# RFI 456 Girder 5, FS 18

RFI 456 - G5, FS18

**Field Splice - Node 9163**  
**Design Scenario 1**

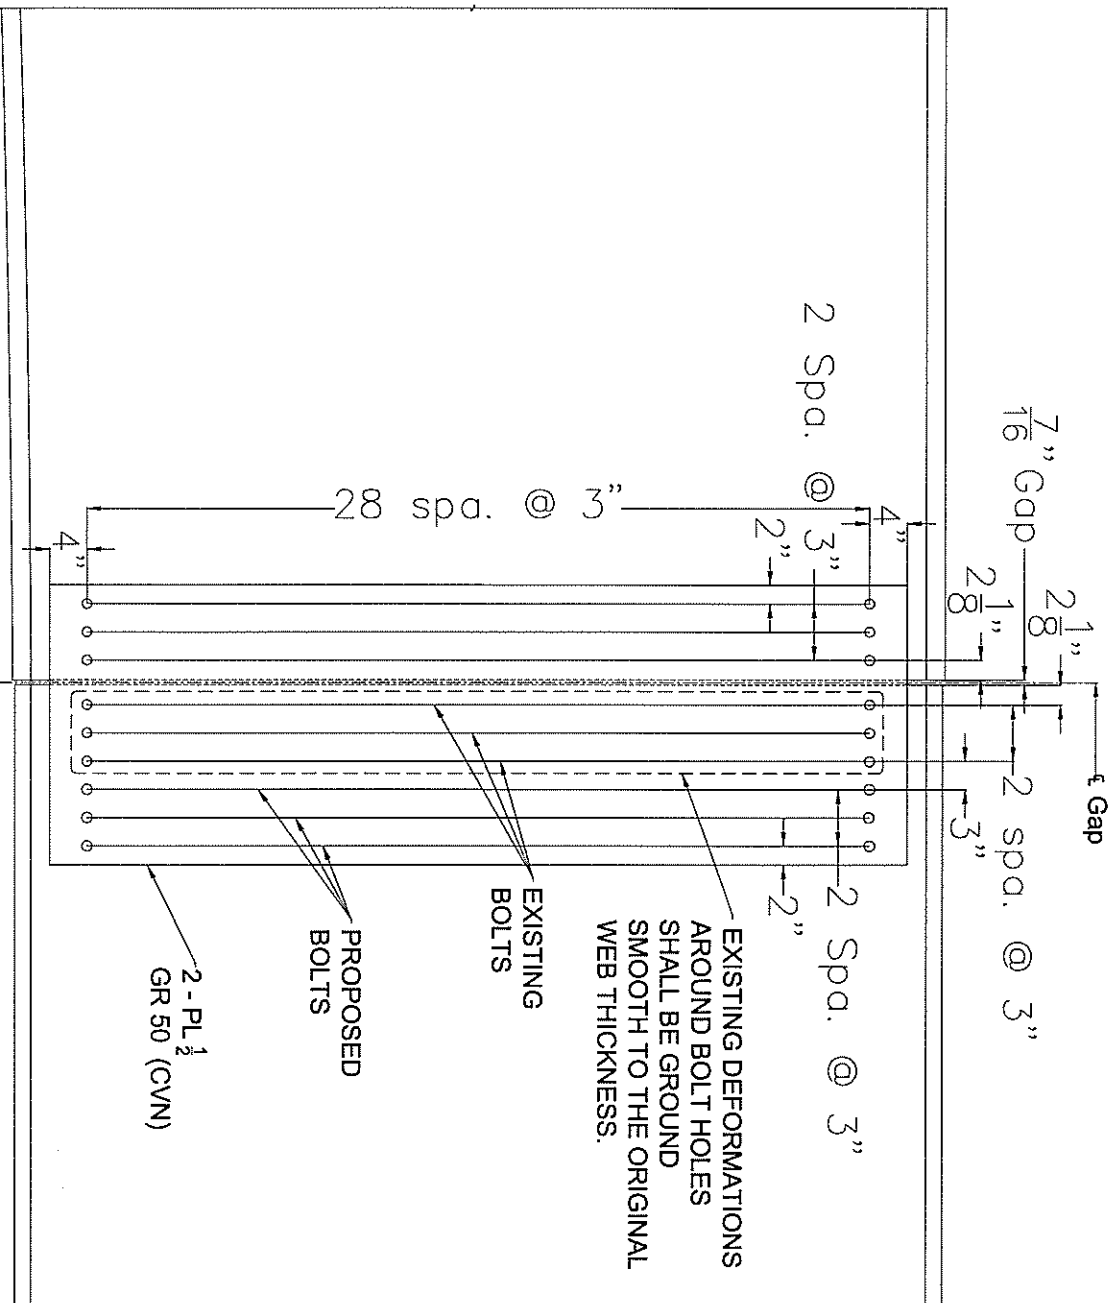
→ FS18, G5 had several holes that incurred damage in the web during fit-up in the field.

→ New columns of bolts are proposed to remedy the damaged web splice.

The gap is ½" between webs. The damage is in the up station piece (Knuckle G5S).

I am working on the calculations to support the proposed fix for FS 18 G5. We don't have the official RFI yet, but I wanted to get started on the design. Could you tell me the field-measured gap distance between girders? Also, which side of the splice is damaged, upstation or downstation?

- NOTES:
1. FLANGE SPLICE NOT SHOWN FOR CLARITY.
  2. ALL MATERIAL AND WORKMANSHIP SHALL BE IN ACCORDANCE WITH THE RFC PLANS.
  3. ALL BOLTS SHALL BE 1" DIAMETER.
  4. ALL EXISTING HOLES SHALL BE DYE PENETRANT INSPECTED IN ACCORDANCE WITH ASTM E165, TYPE 1 FLUORESCENT PENETRANT TESTING, METHOD C. THE INSIDE SURFACE OF THE HOLE SHALL BE INSPECTED. PRIOR TO INSPECTION, THE INSIDE SURFACE OF THE HOLE SHALL BE CLEANED OF ALL DIRT, GREASE AND OTHER SUBSTANCES IN ACCORDANCE WITH ASTM E165, A1.
  5. PROPOSED BOLT HOLES IN WEB SHALL BE FIELD DRILLED 1 1/16" DIAMETER.

Use 7/16" between webs.

## Design Scenario 1

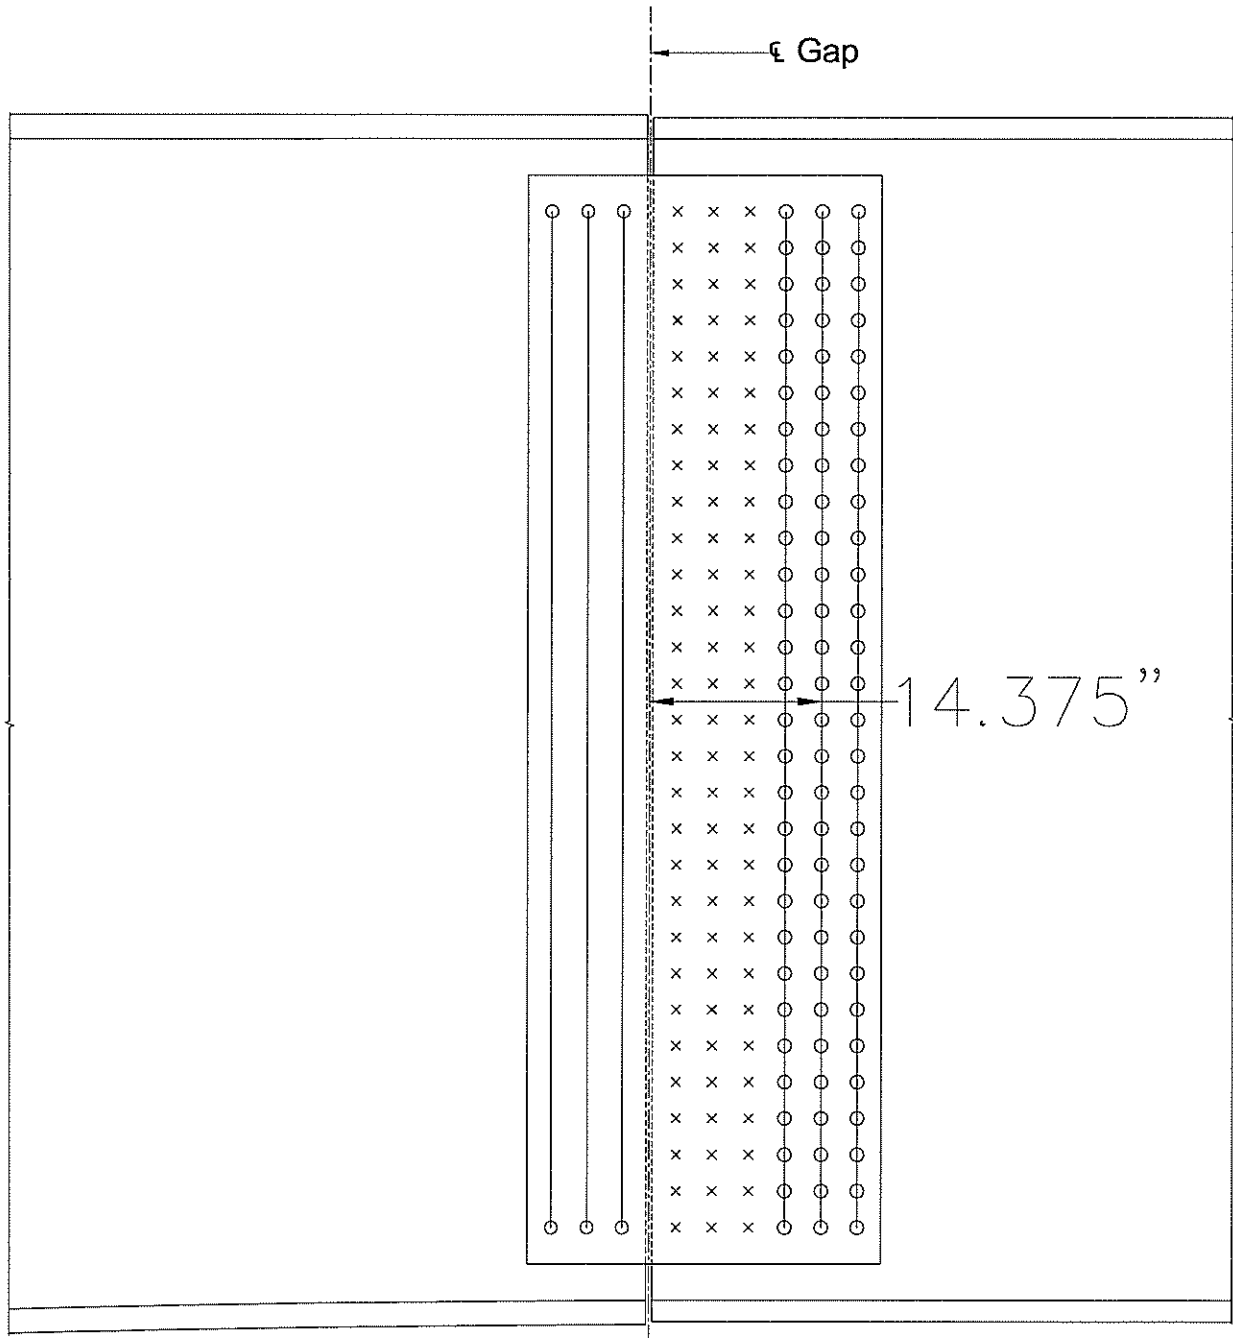
① Right side (damaged side) of the splice not considering any of the damaged holes.

$e = \frac{1}{2}$  of gap to  $\frac{1}{2}$  of new holes.

$$\textcircled{1} e_1 = 2\frac{1}{8}" + 0.5\frac{1}{2} + 2(3") + 3" + 3"$$

$$e_1 = 14.375"$$

## Design Scenario 2

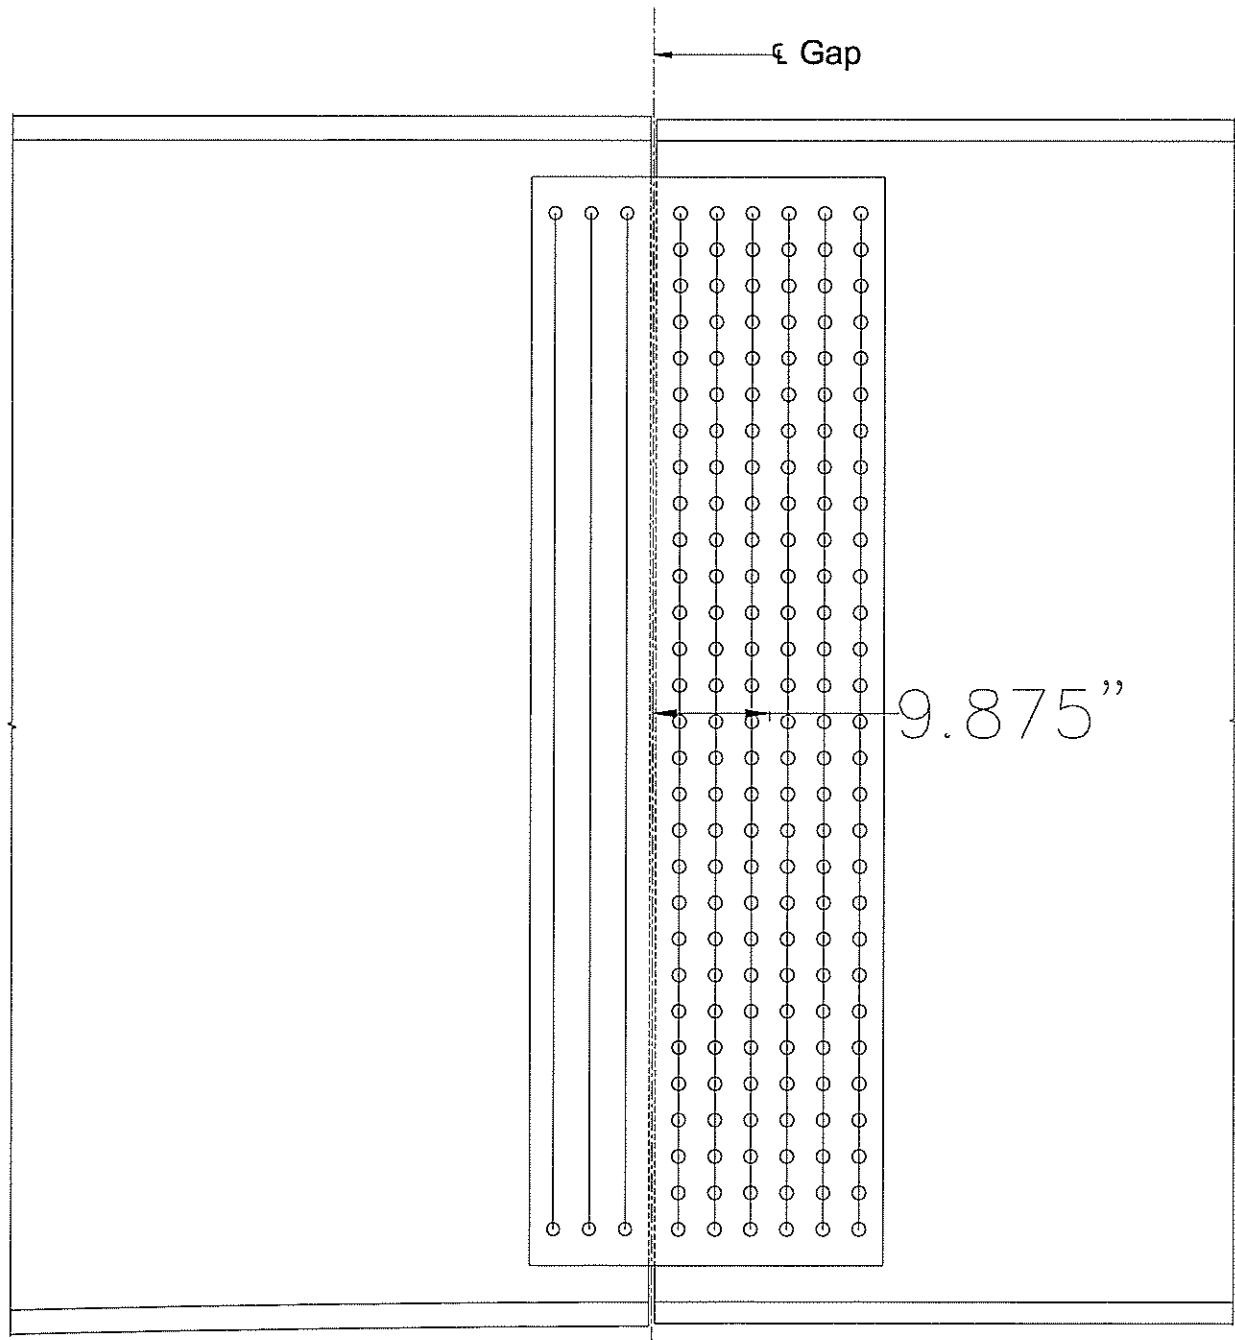
② Right side (damaged side) of the splice considering all holes, both new and existing.

$e = \frac{1}{2}$  of gap to  $\frac{1}{2}$  of all holes on Right side.

$$\textcircled{2} e_2 = 2\frac{1}{8}" + 0.5\frac{1}{2} + (5)(3")/2$$

$$e_2 = 9.875"$$

## Design Scenario 3

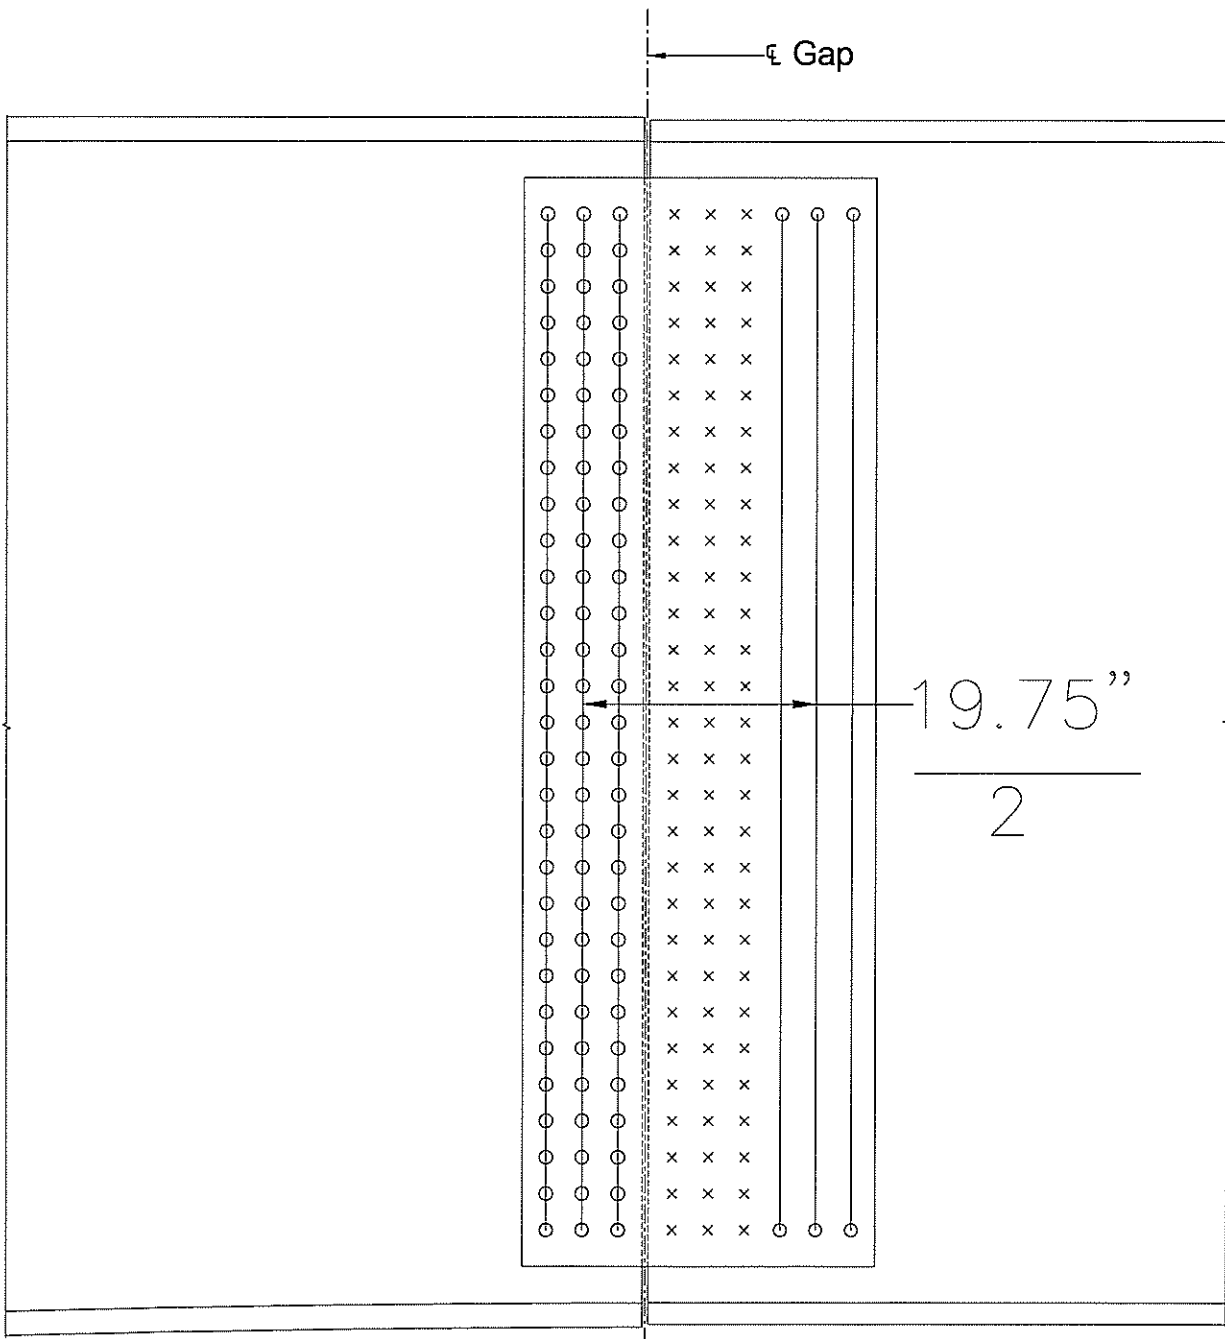
③ Left side of the splice with existing, undamaged holes.

$e = (\frac{1}{2}$  of Left side holes to the  $\frac{1}{2}$  of Right side proposed undamaged holes) / 2

$$\textcircled{3} e_3 = \frac{[(4)(3") + 2\frac{1}{8}" + 0.5" + 2\frac{1}{8}" + 3"]}{2}$$

$$e_3 = 9.875"$$
